Delegated Report

Planning Application No: 20221206

Location: Cedarwood House 86A Central Avenue Gravesend Kent

Description: Application for a minor material amendment to planning permission reference no. 20191288 for creation of a new single dwelling and re-allocation of the garden space of 57 to allow for extra garden space for the new dwelling; to allow the change in window sizes and introduction of a new window in the loft space, retention of shed and inclusion of hard and soft landscaping details and boundary treatment.

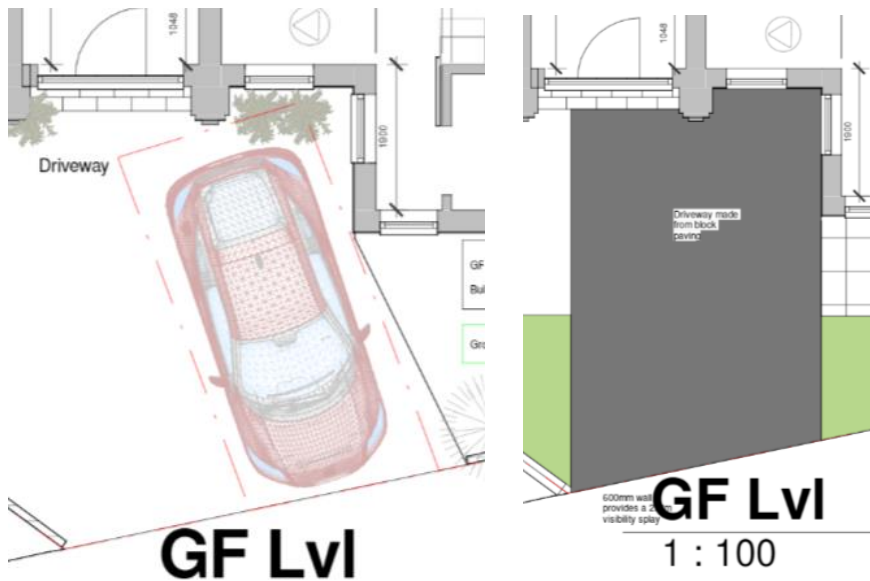
The Google Street View image below, taken in November 2022, shows that by using an existing crossover the car is liable to be parked in front of the front door and the pedestrian visibility splay may be compromised by the side wall and the gate when opened, all of which are unacceptable and unsafe.

Officer Note: It is noted that since the GB Highway Officer raised these comments the driveway was reinstated to the previously approved position in the plans provided.

Block Plans/Lay out

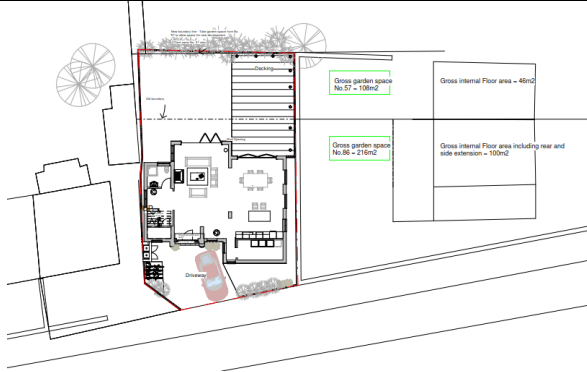
In terms of landscaping the rear garden would have an area soft landscaping, with paving slabs in the lower rear garden and concrete paving to the upper level of the garden, extending to the front. The driveway itself would have an area of permeable block paving. The boundary treatment proposed would be acceptable. However, it is noted that a front gate over 1 metre high is currently installed. This application would not find this acceptable in terms of design and highway safety and this gate should be removed. The condition would continue to be attached, which would ensure that no boundary treatment within the visibility splay above 0.6m metre high shall be installed.

Hedging/boundary treatments to the front should be maintained at 1m high or below. There is no space for provision of soakaway to front so all hard landscaping fronting the property should be permeable. The driveway has been shown to be permeable. Also, through the course of this application the boundary treatments have been amended to ensure that there is not boundary treatment of any height within the sight lines. It is noted that the initial scheme sought to alter the position of the driveway from that originally approved but this would have likely result in unacceptable sight lines and so the agent altered this to reflect

the original proposal as advised. The highway concerns based on the above assessment have been addressed.

Elevations (LH and RH)

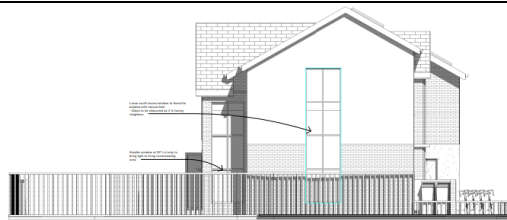
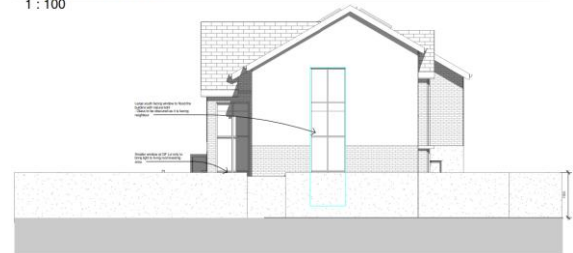
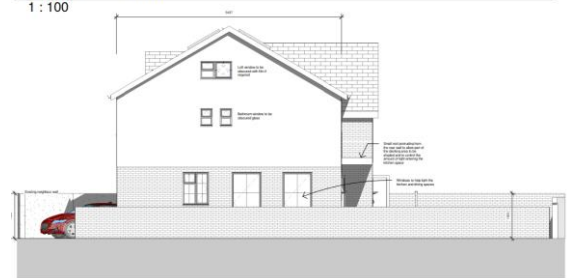
Of necessary further consideration is the altered fenestration, landscaping and boundary treatments. The additional loft floor window provided to the Right-hand elevation would be appropriate in terms of scale and size for a residential dwellinghouse of this size. Whilst it is unfortunate that the first floor window of the same elevation would be reduced in size, appearing somewhat incongruent with the ground floor openings, the reduction of size for side facing openings, would not result in significant harm the character of the area. Again, the reduction in size of windows to the rear elevation are also unfortunate as they do not match other openings particularly well. However, given their rear location and proximity to the neighbouring property, this would be a reasonable adjustment. Shifting the rooflights higher on the roof slope would also be a minor change unlikely to significantly impact the appearance of the dwelling house in the street scene.
